Rose Cottage, Vale of Health, NW3 1AX
Addendum to planning application 2018/0887/L
21.02.2018

180221_135_REP_RenderUpdate

1. Existing Render
2. Proposed Render
3. Method statement and test
4. Typical window reveal
5. Interface between render and main part of building

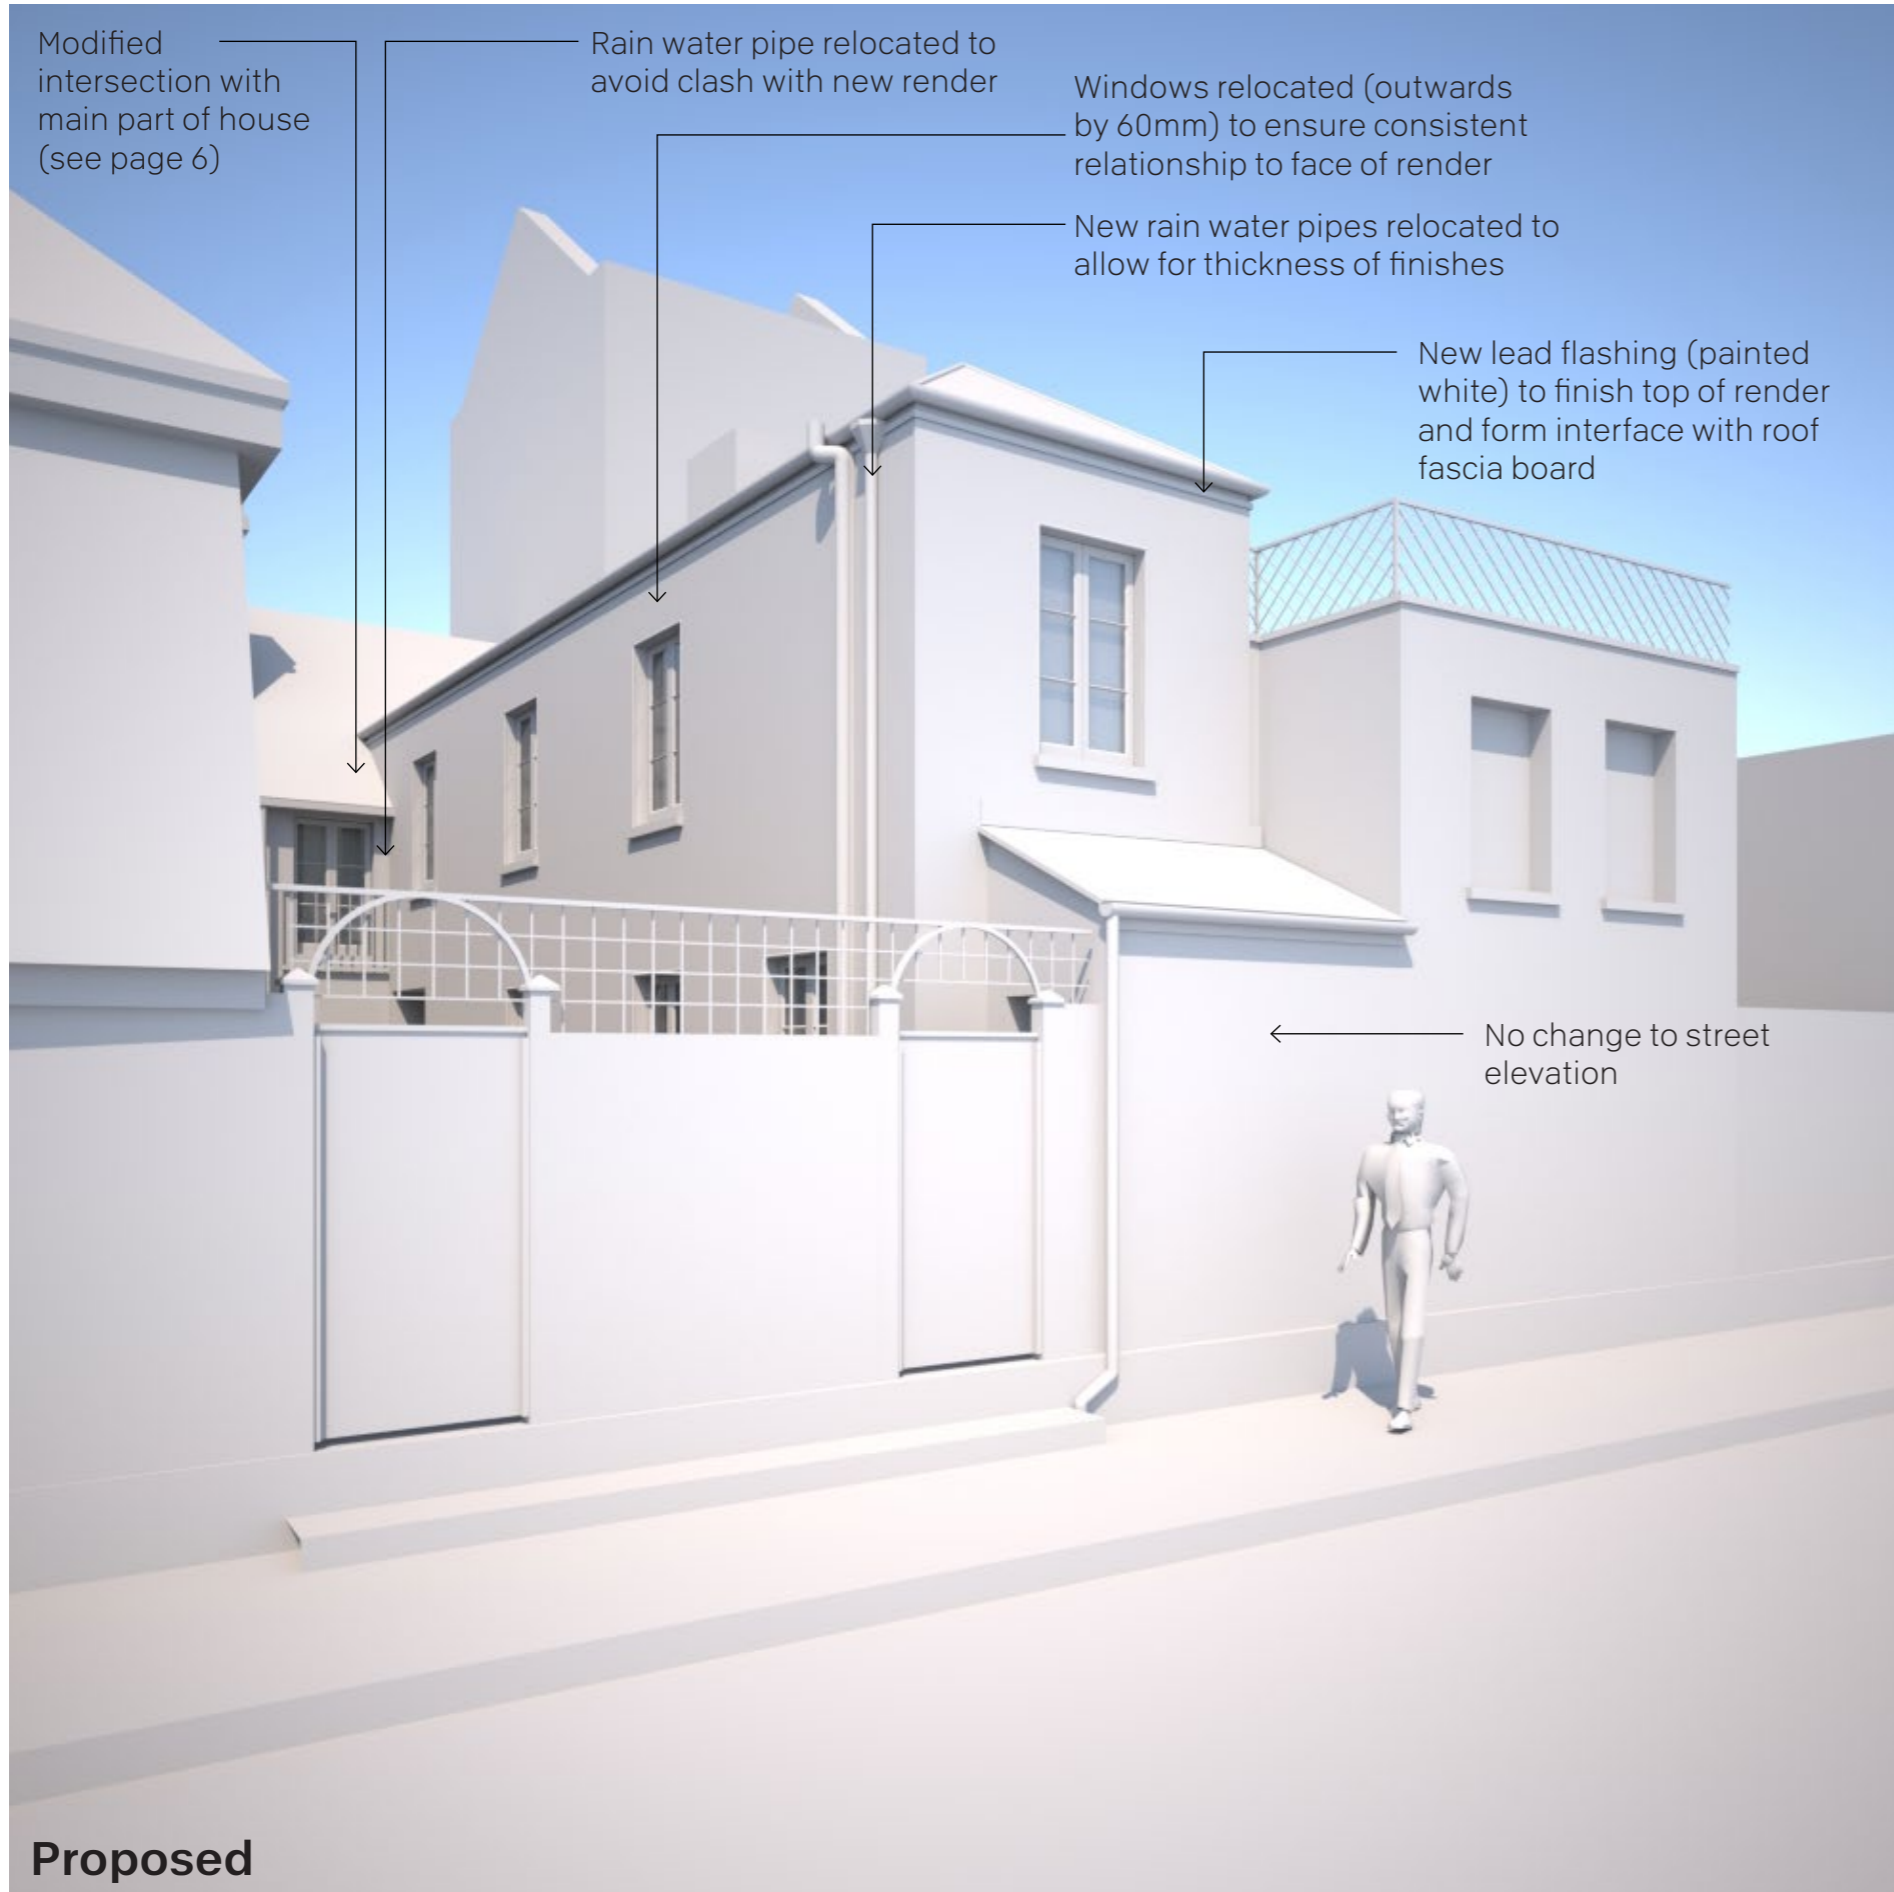
Existing

Proposed

Observations from area of test removal

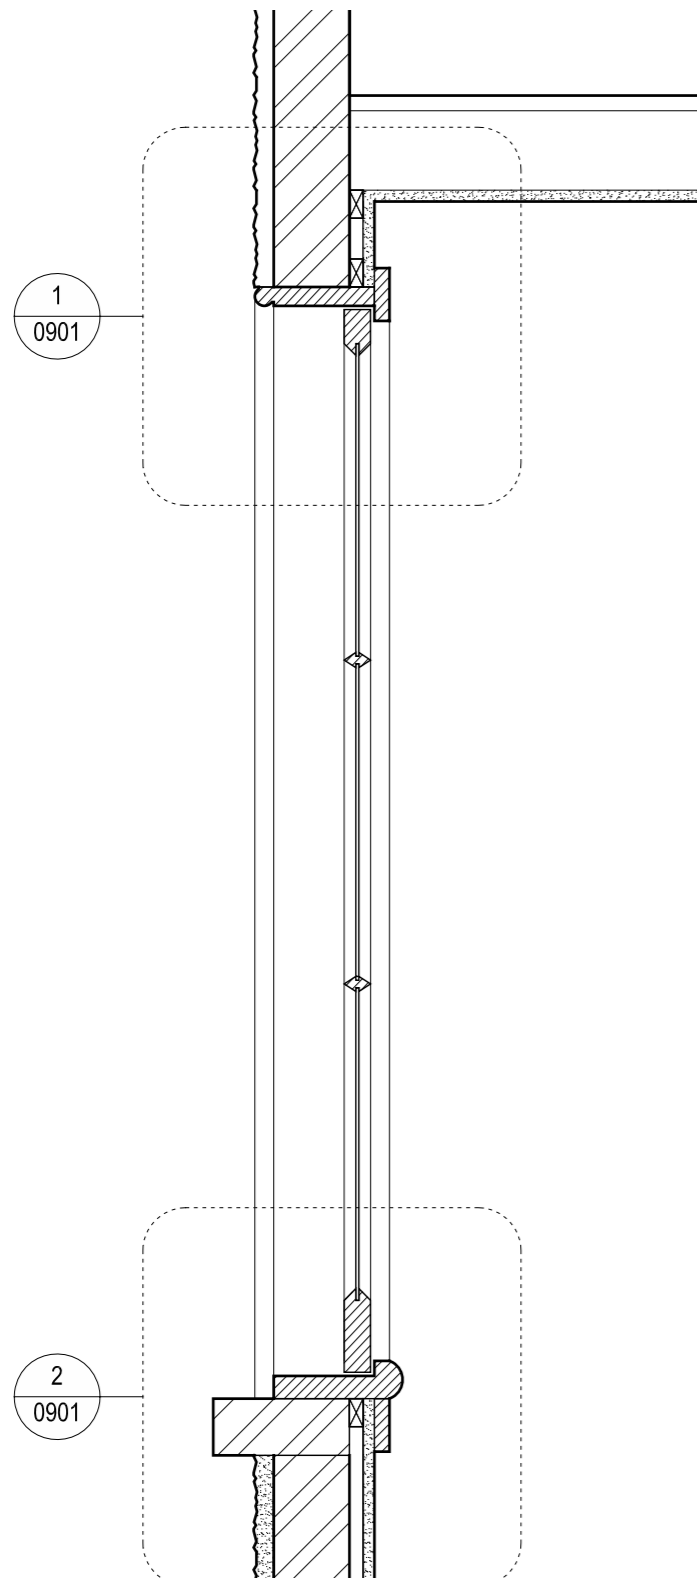
- Contractor followed proposed method statement
- Render comes away easily with no damage to brickwork, pointing or timbers
- From this section of the wall the conclusion would appear to be that the wall is at least partially comprised of timber structure with brick infill.
- In some areas slate coverings appear to be forming a form of DPC protection to the timber. This is not consistent.
- Brickwork is in reasonable condition with some areas of loose pointing requiring attention
- Modern mesh found in render coat confirms expectations that Render is non-original

- Method statement is fit for purpose
- Render is non-original
- Extensive use of timber as part of wall structure
- Render can be removed effectively without damage to brickwork

Proposed
Section 1:10

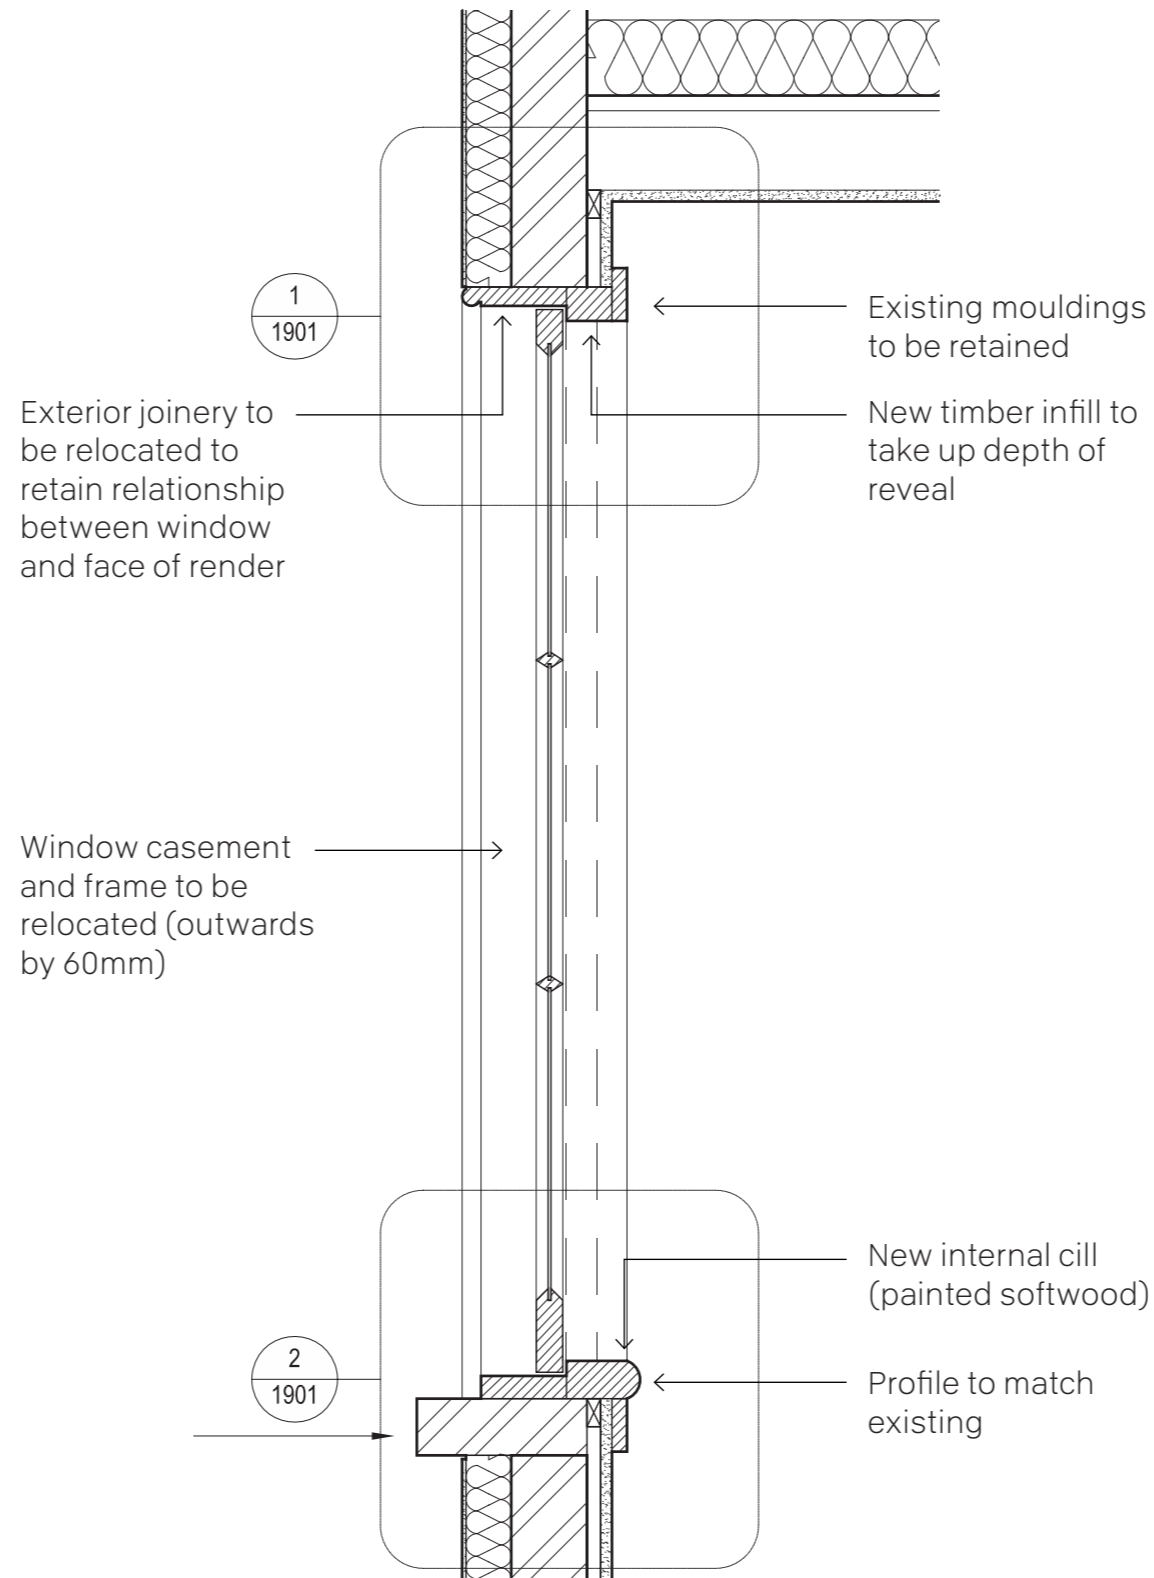
Window relocation

1. Following removal of surrounding render:
2. Carefully remove window casements.
3. Remove any damaged putty
4. Strip away excess paint
5. Protect casements and set aside for re-use
6. Carefully remove internal mouldings, strip off excess paint and set aside for re-use
7. Take out window frames and external window reveal timbers. Strip off excess paint and set aside for re-use.
8. Reinstall window frames and window reveals to align with face of new render build-up.
9. Reinstall casement windows to new position
10. Reinstall internal mouldings including any filler pieces necessary to make up internal reveal depths
11. Install new deeper window cills
12. Redecorate windows and all joinery and replace putty where necessary.
13. Complete internal and external finishes around window joinery.

In the event that any glass or timber is found to be significantly damaged it is to be replaced like for like to match existing.

Existing

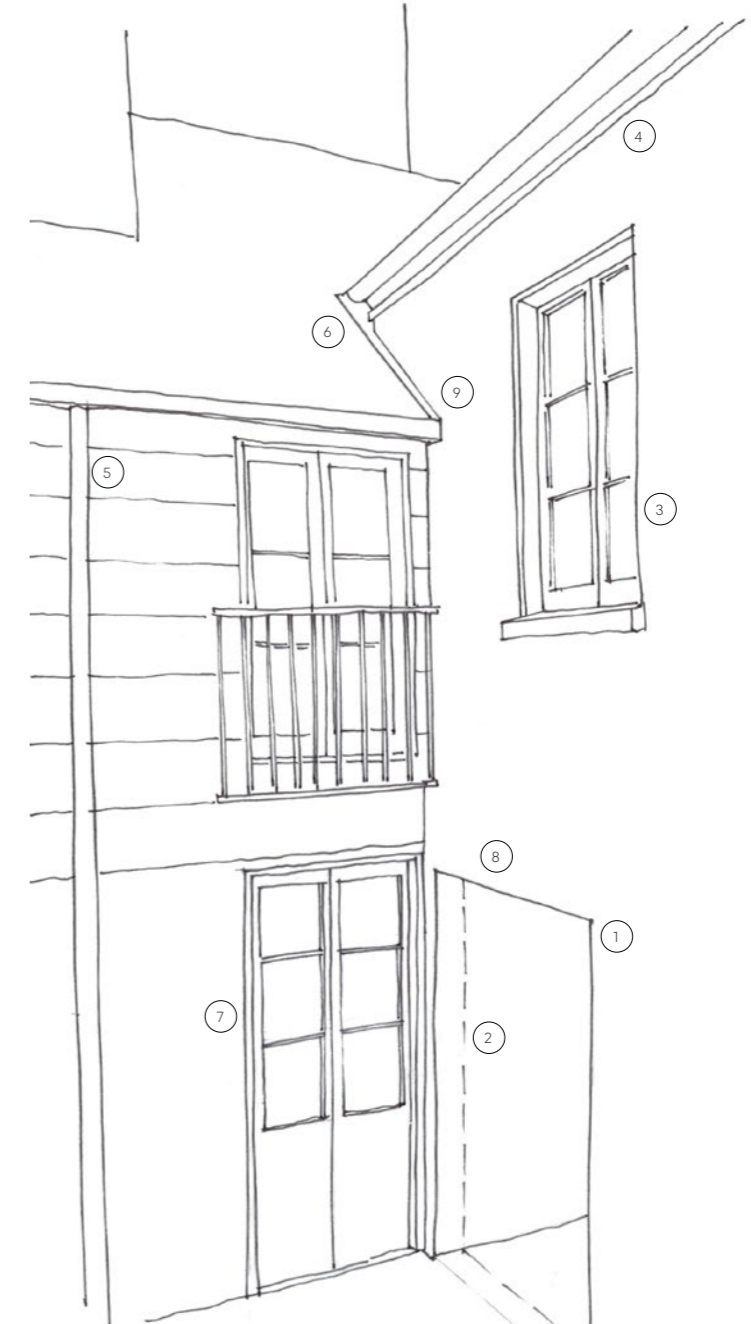
- 1. Existing door
- 2. Exposed steel lintel
- 3. Downpipe
- 4. Fascia board
- 5. Lead flashing detail

- 1. Render finish
- 2. Potential opportunity to locate door further forward and enclose porch area
- 3. Window relocated to maintain relationship to finish
- 4. Painted lead flashing to make junction between render and fascia board
- 5. New downpipe location
- 6. Lead detail adjusted to allow render to lap over flashing
- 7. New doors (previously consented)
- 8. New finishes to conceal exposed lintel
- 9. Gutter trimmed to allow for render
